HIROSE ELECTRIC CO., LTD.
2-6-3 Nakagawa Chuoh, Tsuzuki-ku, Yokohama, JAPAN

Product Specification Change for HIF3, B, C, M, and FX2B Series

■Product list PCN2025-06-8 Product Specification Change for HIF3, B, C, M, and FX2B Series

Supplementary Documentation for Product Changes in HIF3, B, C, M and FX2B Series

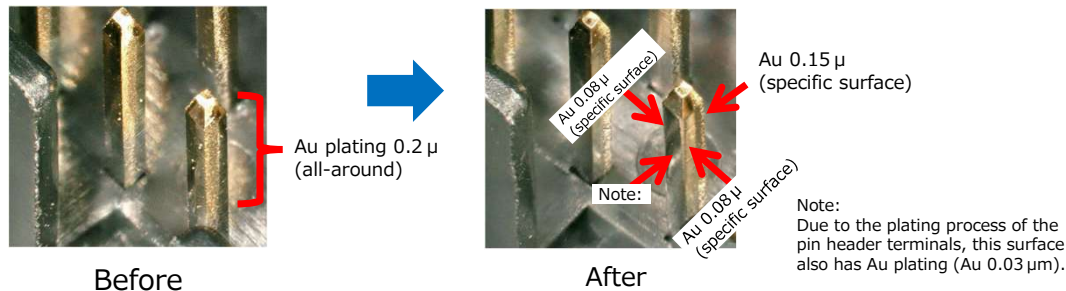
Change 1 Change the lock shapes from standard width to wide shape type for items H① to H⑤.

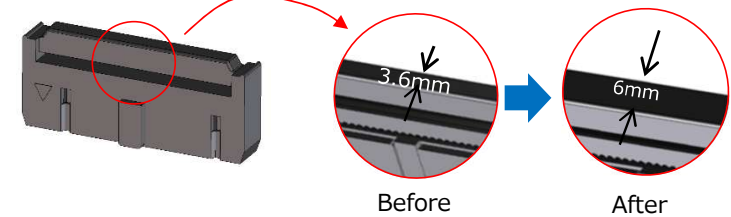
Change 2 Change in plating specification for the contact area of pin header terminals H① to H⑦. (Change from full-surface Au 0.2 μm plating to a specification with different Au thicknesses depending on the surface.)

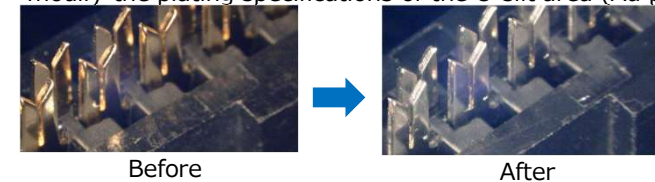
Change 3 H⑧ Change the clamp part of item ⑧ from standard width to wide type.

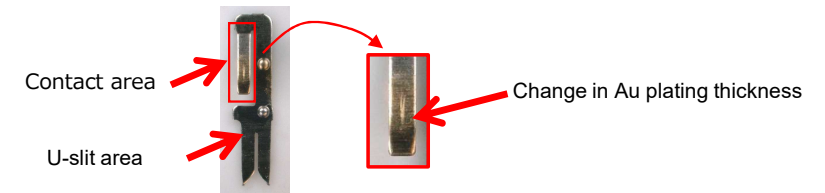
Change 4 H⑧ Change the terminal material of item ⑧ (within copper alloy types) and modify the plating specifications of the U-slit area (Au plating → Ni plating).

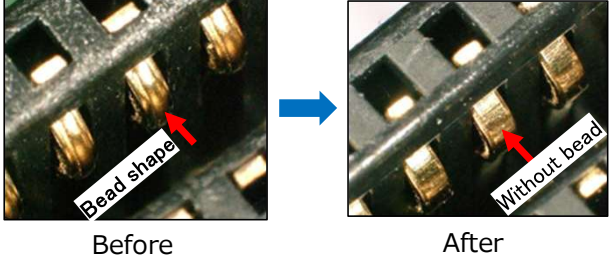
Change 1 Change the lock shapes and external dimensions for items **F①**, **F②**, and **F③**.

⇒ It is necessary to purchase an additional set of guide blocks (left and right).
 Part number for the left guide block: FX2BR-GPA(71)
 Part number for the right guide block: FX2BR-GPA(72)

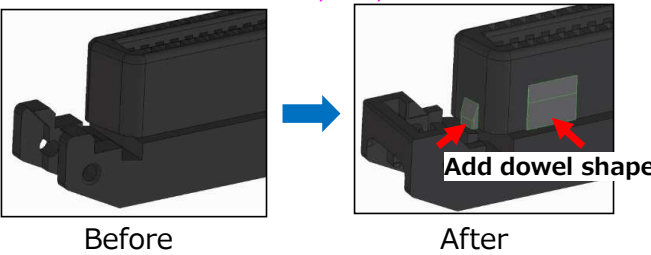
Change 2 Change the terminal material of items **F①**, **F②**, and **F③** (within copper alloy types) and modify the contact area shapes.

Change 4

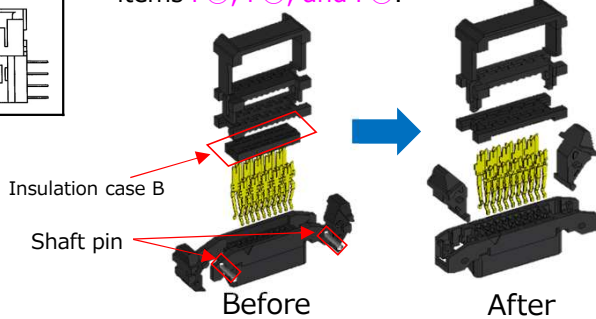
Change the number of parts used for items **F①**, **F②**, and **F③**.

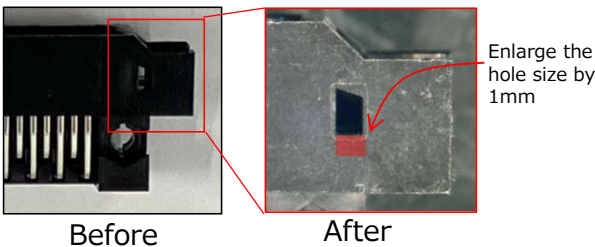
Change in the number of mechanical operations from 500 to 200 times in the specification tables for items **F①** to **F⑤**.
